Subject: TS45 Air Tank strings replacement Bulletin Type: FC

Bulletin No: TS45-FC-2512

Vehicle Model: TS45

Due to the freezing issue observed in the cable of the air tank drainage system in TS45 model vehicles, a revision has been implemented.

Figure 1 - Old Rear Air Tank Drain systems must be demounted.

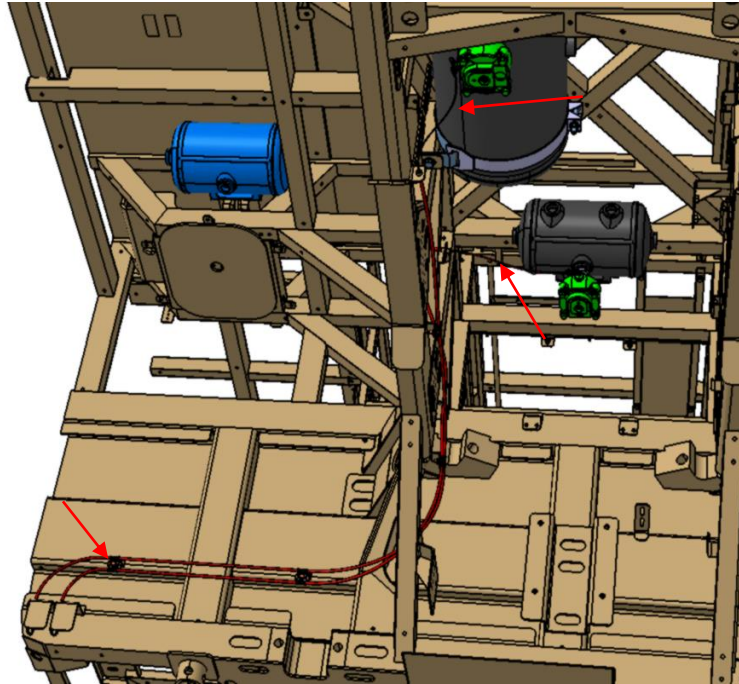
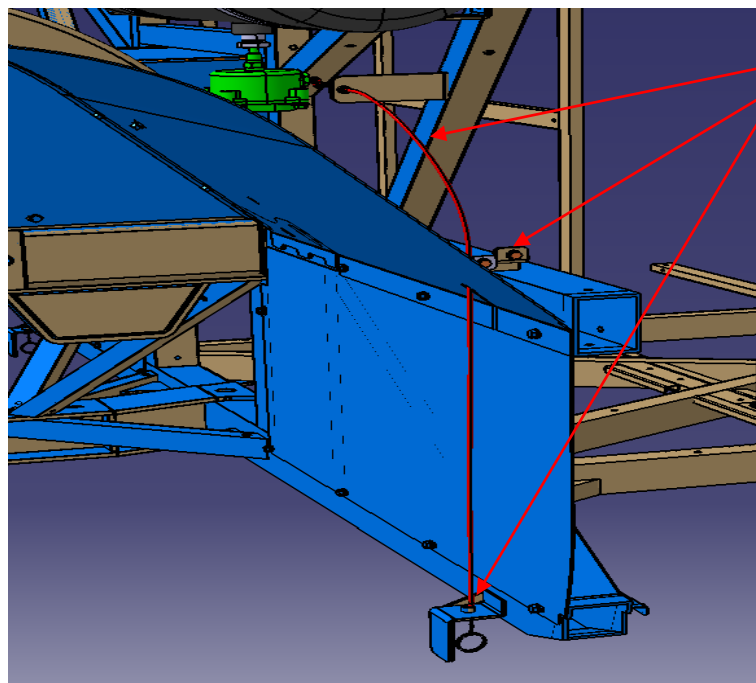
The bus must first be moved to the maintenance bay to facilitate operations on the rear air tanks. Once relocated, the old systems are to be dismantled and removed from the vehicle.

These parts must be dismantled

Figure 3 - Front Brake Air Tank Drain System on Right Side

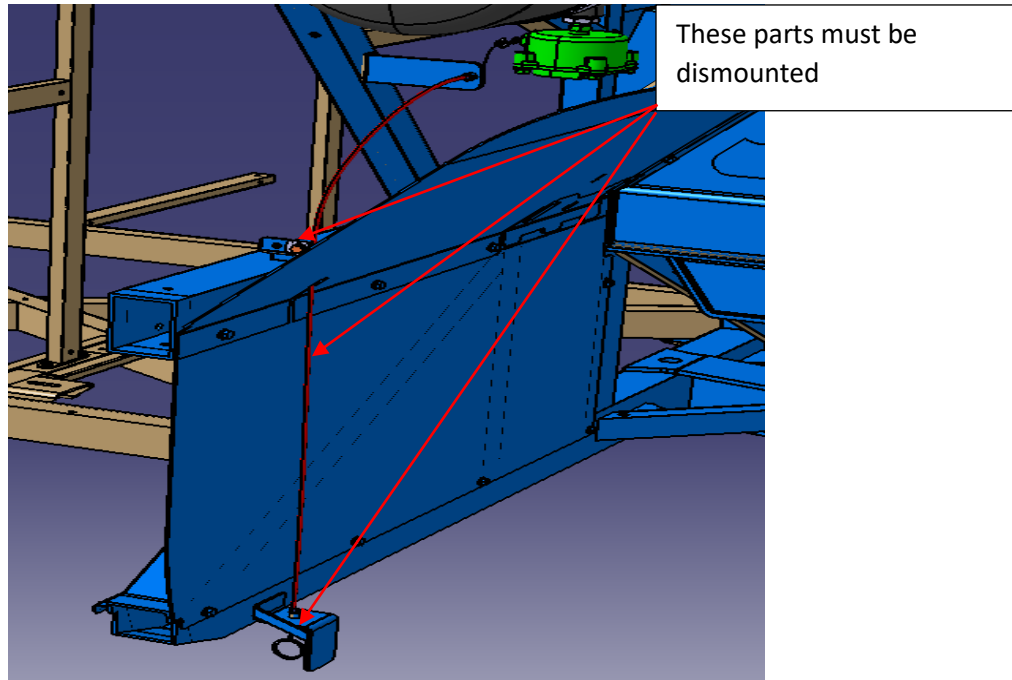
The old systems were removed from the bus. It is recommended to cut and remove the brackets located at the bottom. To facilitate the process, the steering system should be turned to the left while cutting and removing the bracket positioned on the lower right side.

Figure 13 – String Connection to Air Tank Detail on New System in Front Side

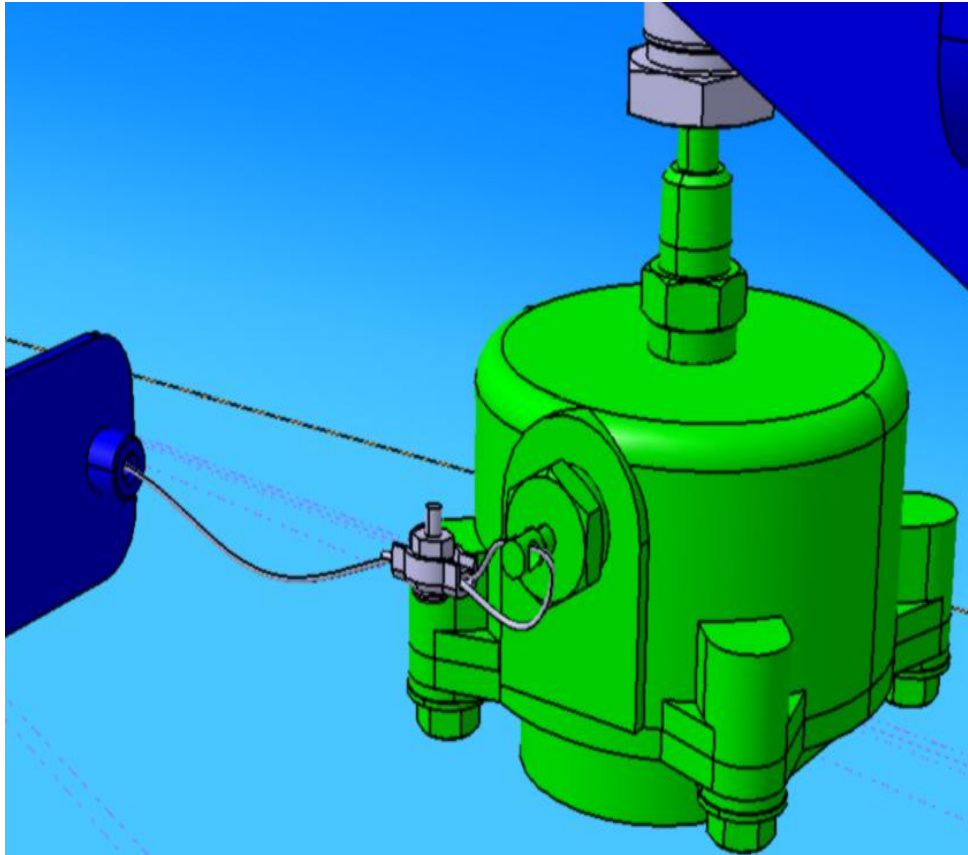
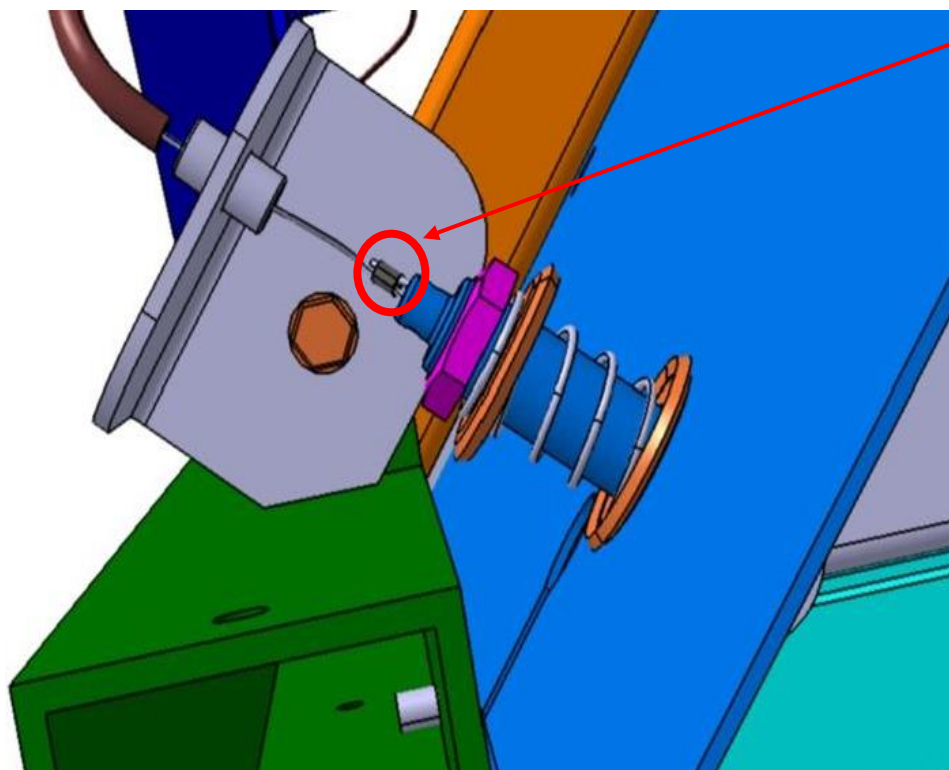
This copper clamp must be tighten after the string is adjustment
